RE: Electric Owl Holdings, LLC: Petition to Amend the Code of the Village
Site: One South Broadway, Hastings-on-Hudson, New York

On behalf of Electric Owl Holdings, LLC (the "Applicant"), we respectfully submit this letter in response to a November 14, 2023 Memorandum prepared by Cleary Consulting and in furtherance of the Application pending before the Village seeking to amend the Code to establish a "Multimedia Production Studio Overlay District." This letter further supplements the Application and follows the November 22, 2023 letter submitted by Cuddy & Feder LLP on behalf of Electric Owl Holdings, LLC (the "November 22 Letter").

DRAWING NO: L 3.0
SITE SECTIONS A

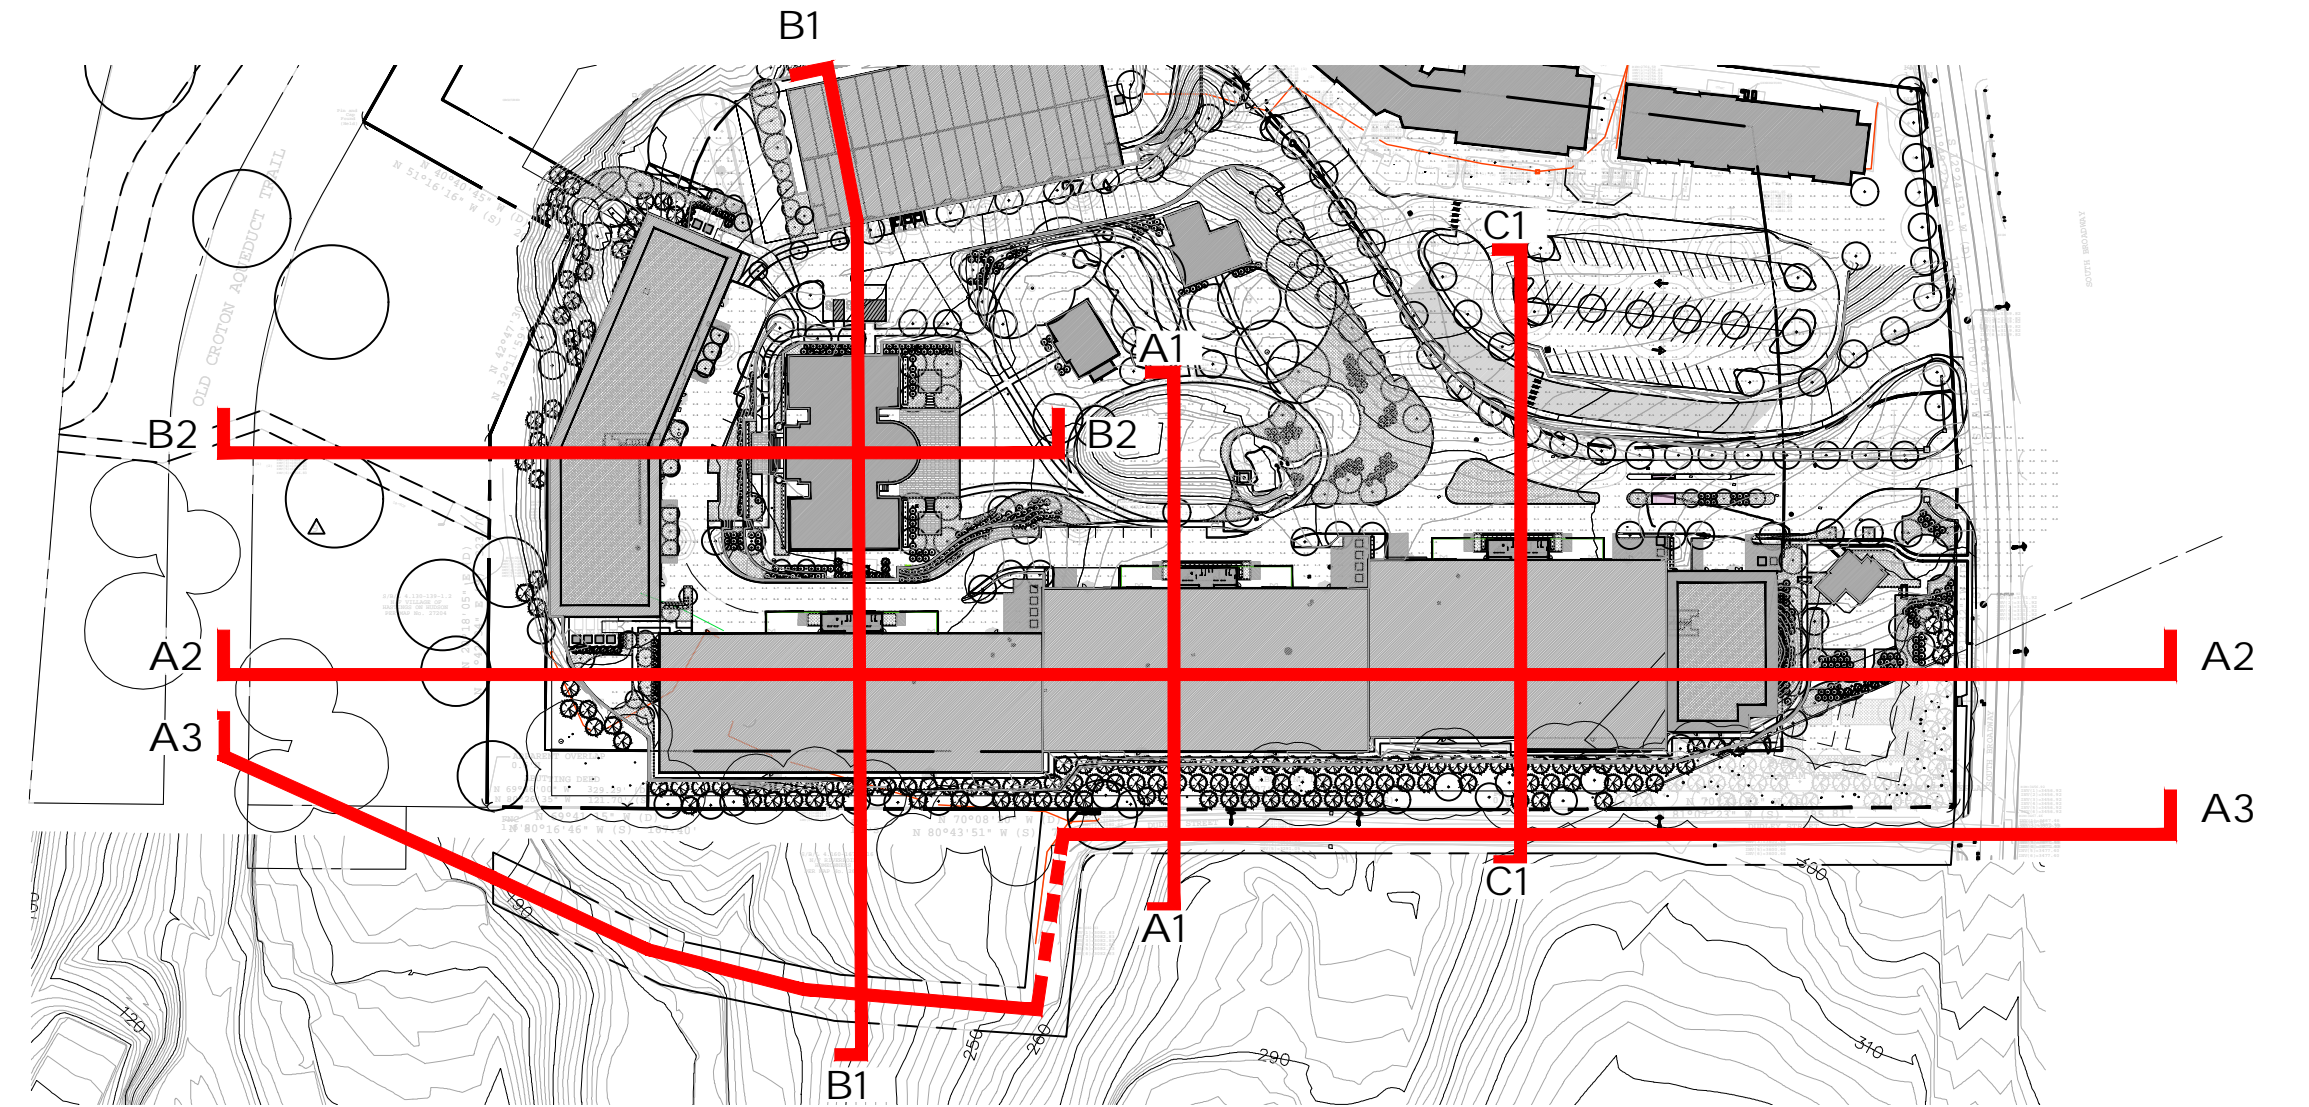
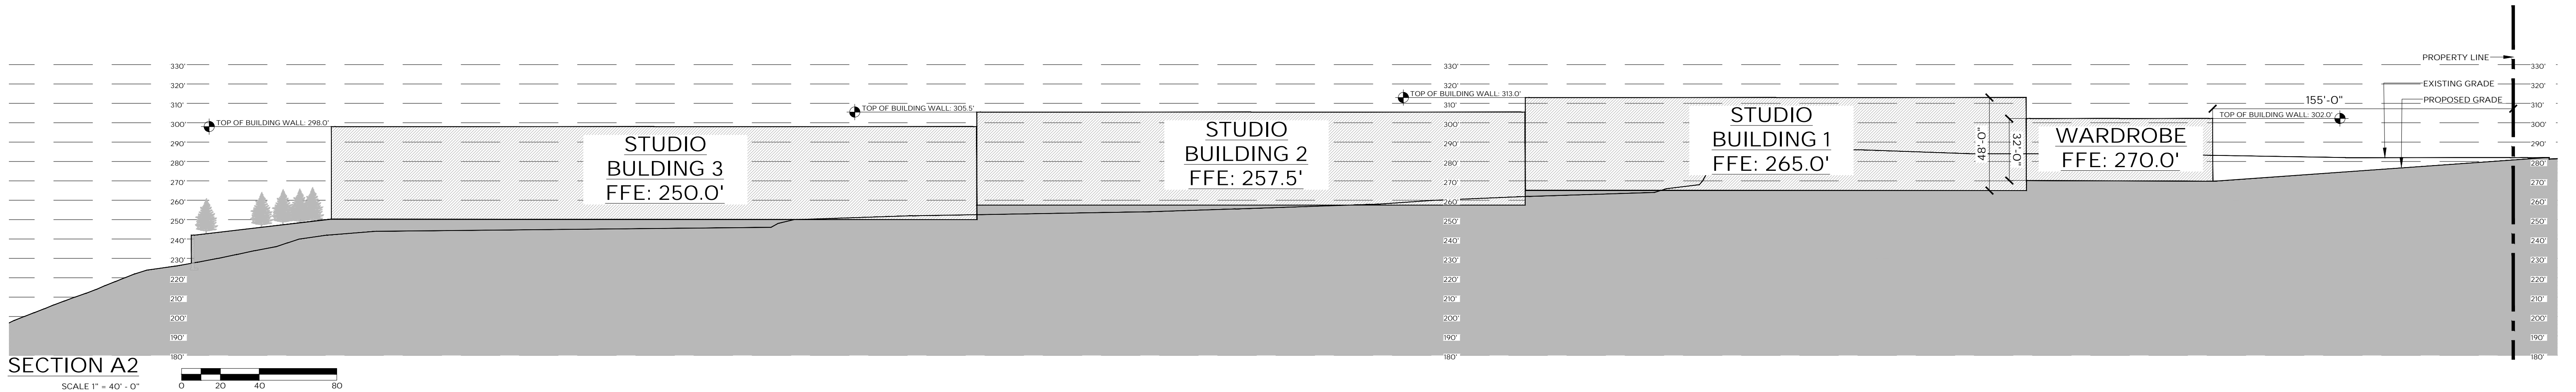
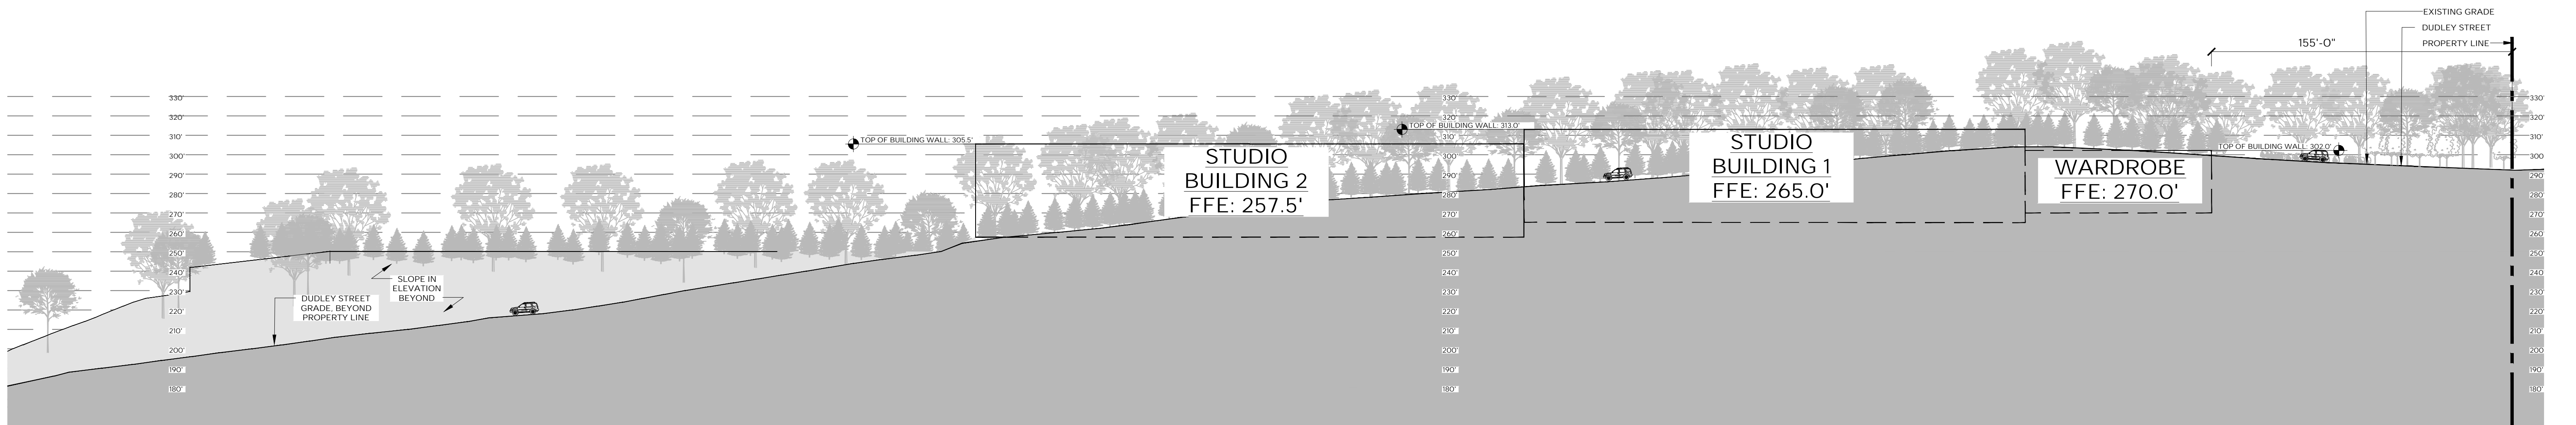
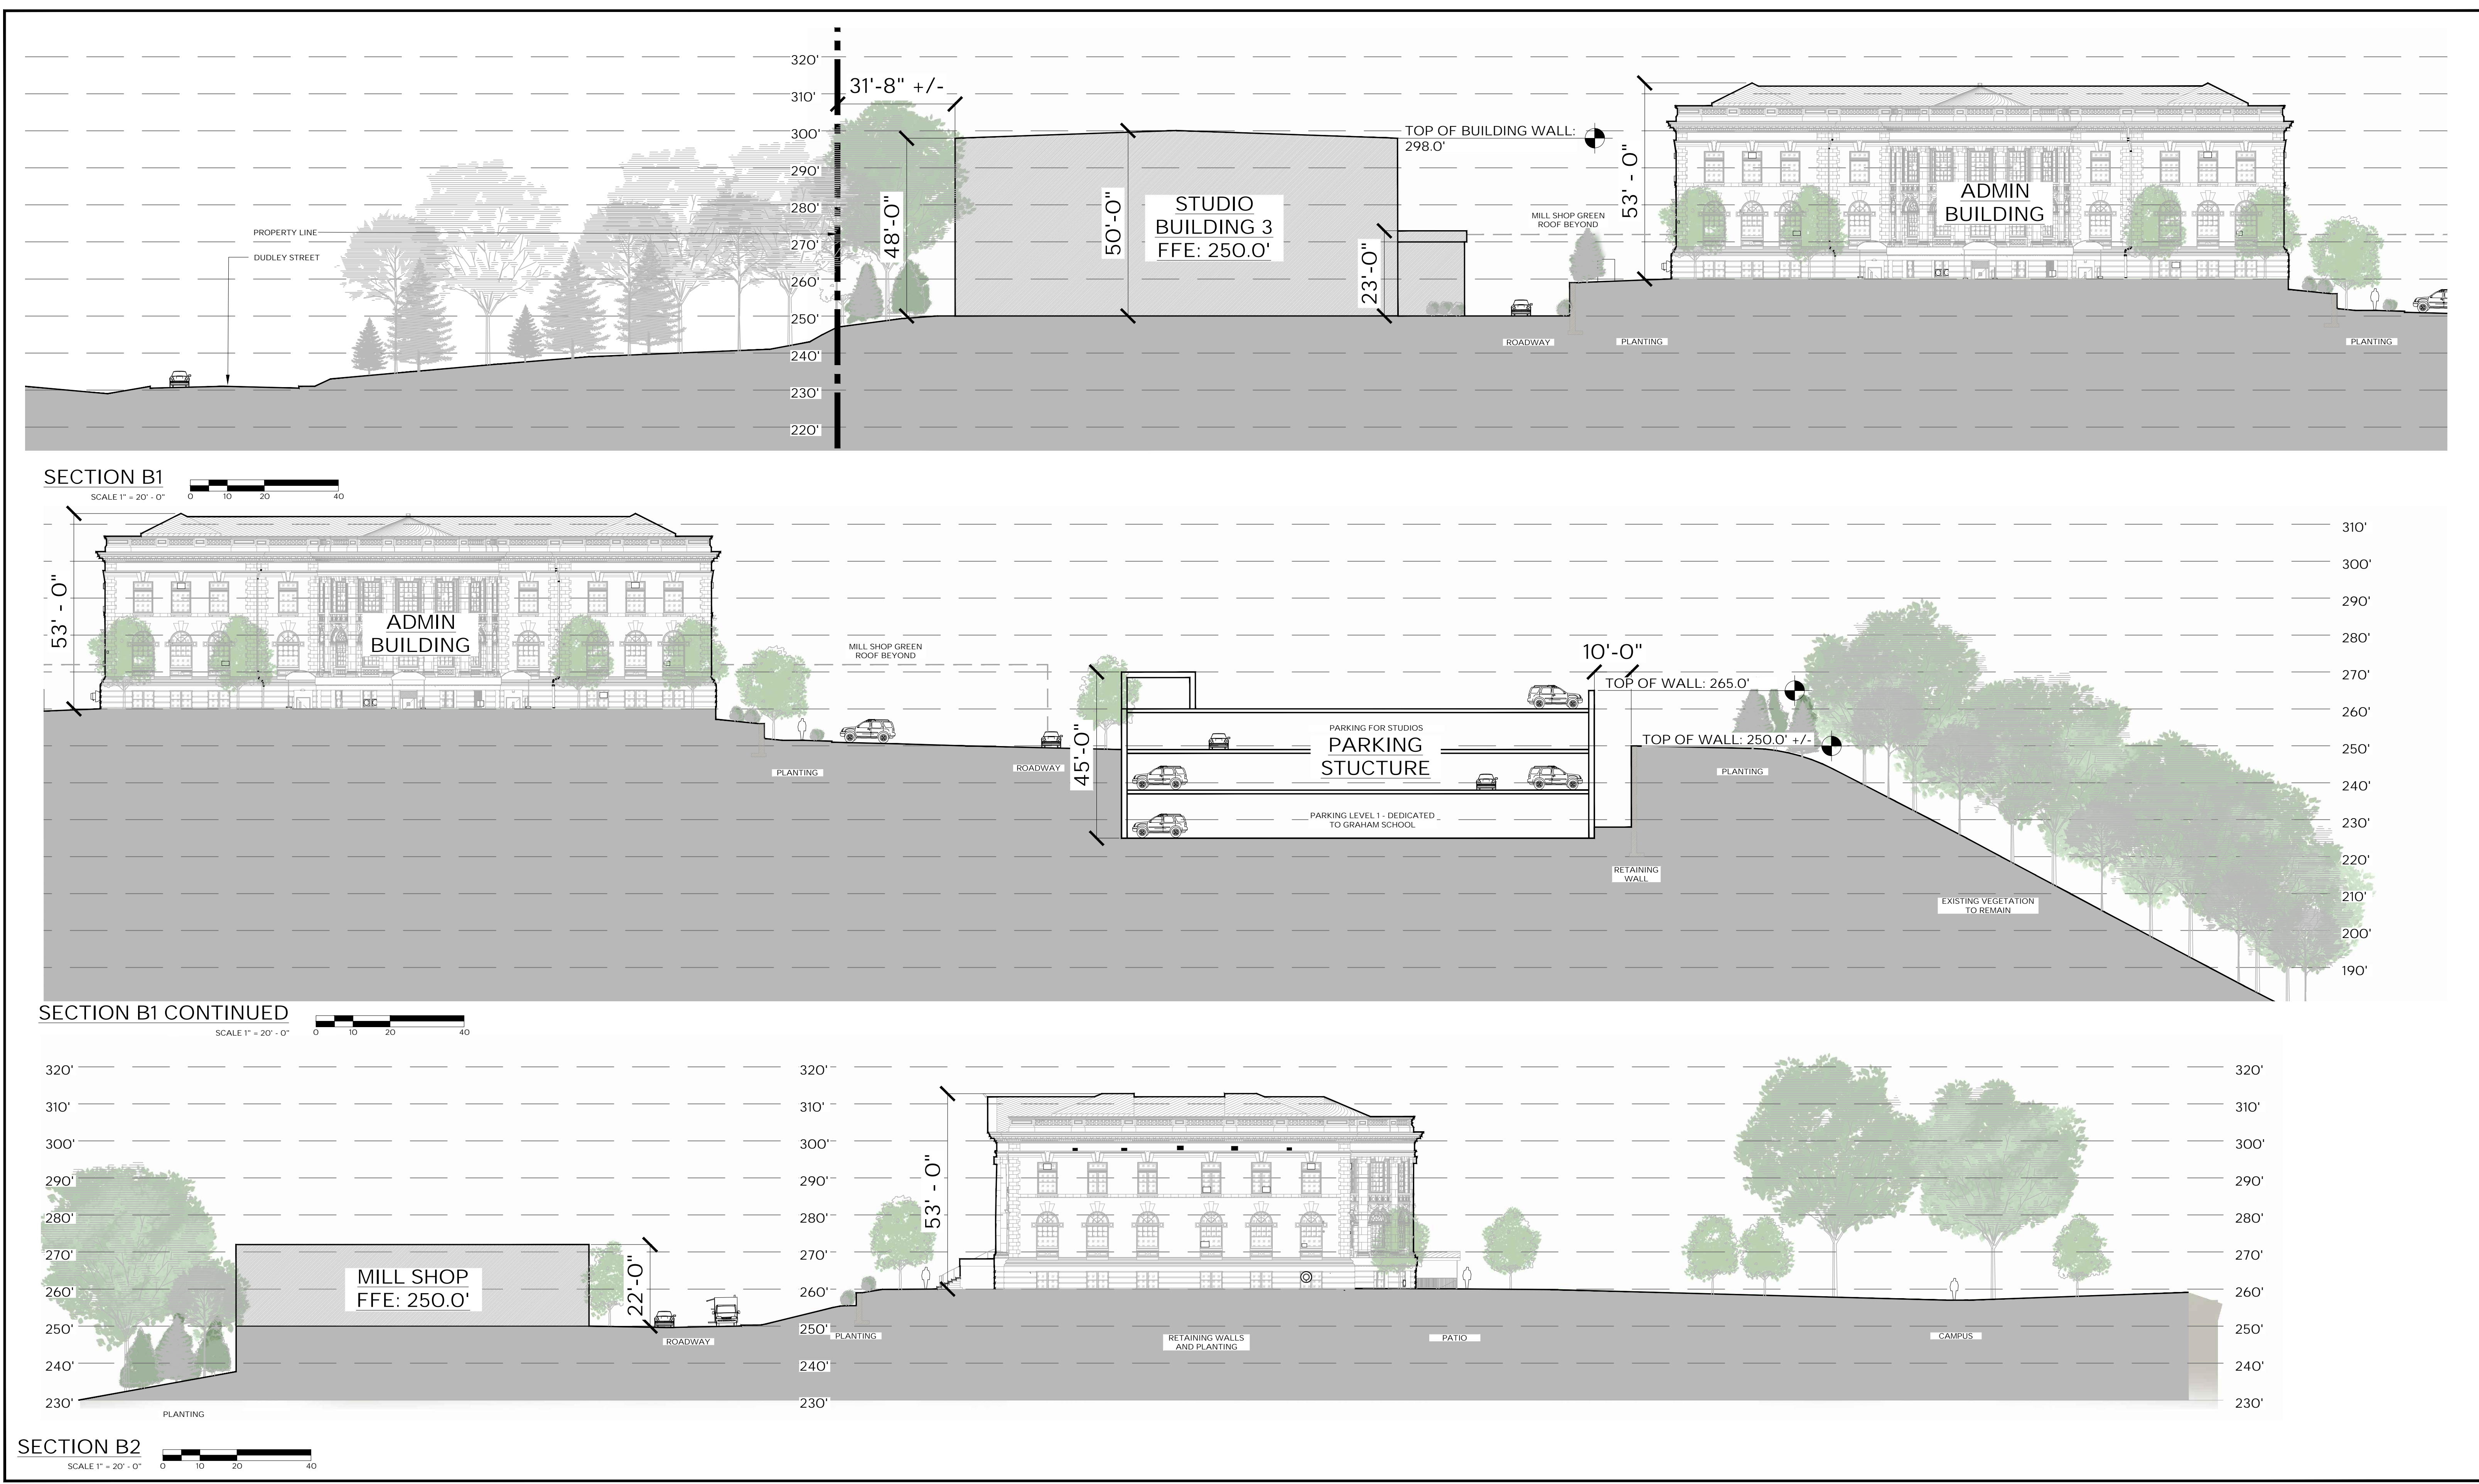
c. The Applicant was asked to provide grading information to better illustrate the height of the studio building walls. (Comment 6)

Cross-section drawings of the Studio buildings and parking garage have been revised to highlight the proposed grading and heights of buildings, as requested in the Cleary Memorandum. Accordingly, enclosed are the following plans prepared by Granoff Architects, entitled “Electric Owl Studios, 1 S Broadway, Hastings-on-Hudson,” dated November 28, 2023, as follows:
